Historic Preservation Design Review

HP-11-29, 21 N. Main St. (Rev. 1) – Opera House Clerestory Addition (City)

Sumter Opera House
View of Roof Area with Proposed Clerestory & Windows Above Council Chambers

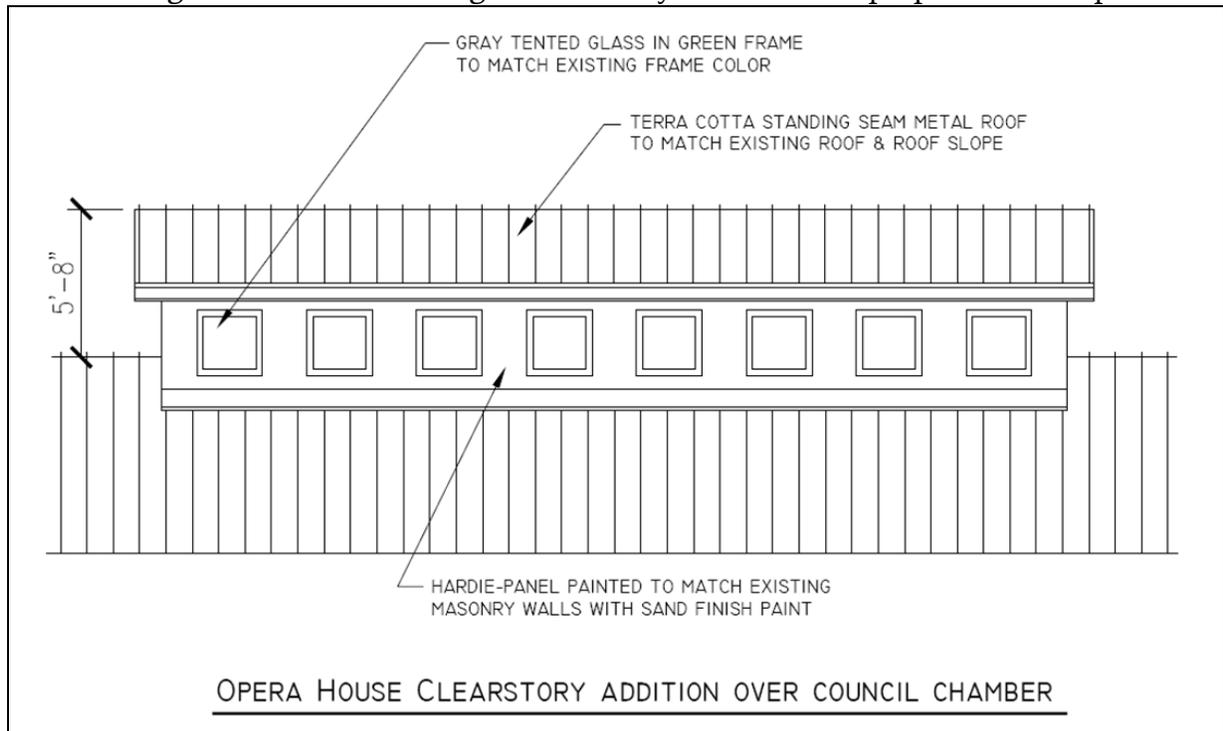
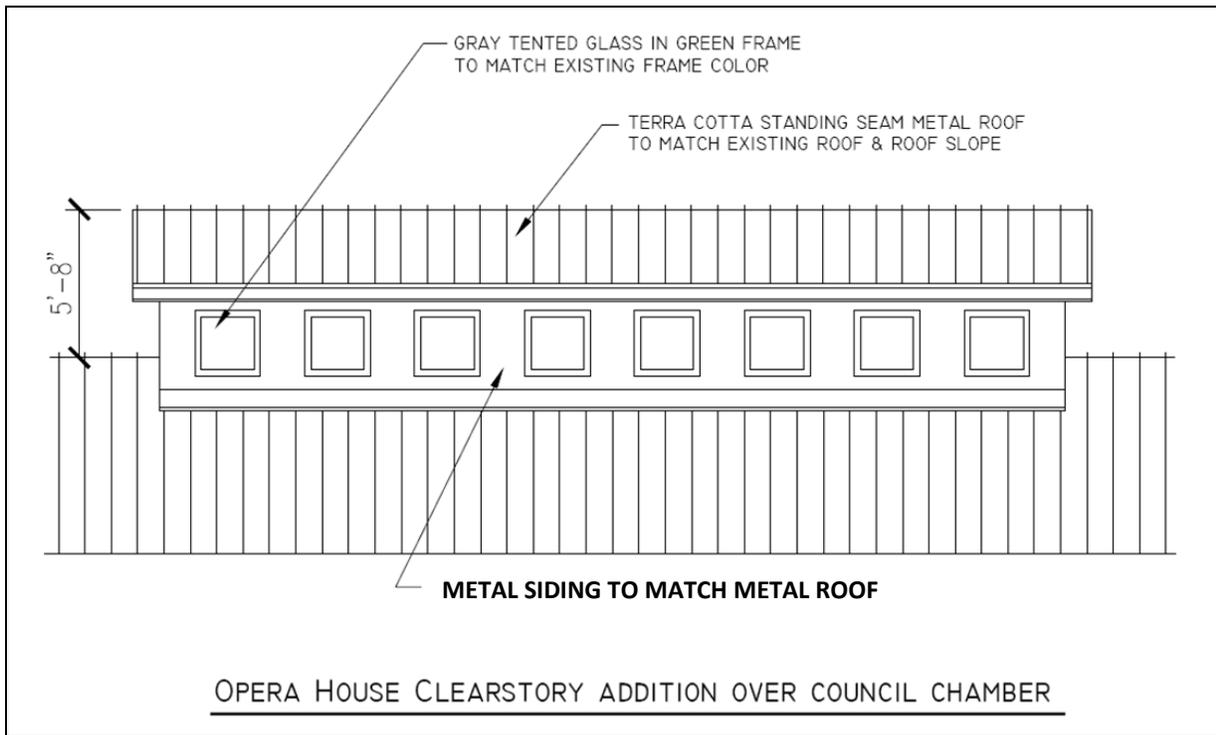
The proposed clearstory addition will raise a total of 5'-8" from the plane of the roof to the rear of the structure. Because of the proposed shape, materials, and color it should blend seamlessly into the existing roofline. The addition will not be visible from the front façade.

The proposed clerestory addition is to be constructed of metal siding with a standing seam metal roof to match the existing structure and aluminum windows.

Staff recommends approval of this request. The proposed project generally meets the requirements set forth in the design review guidelines.
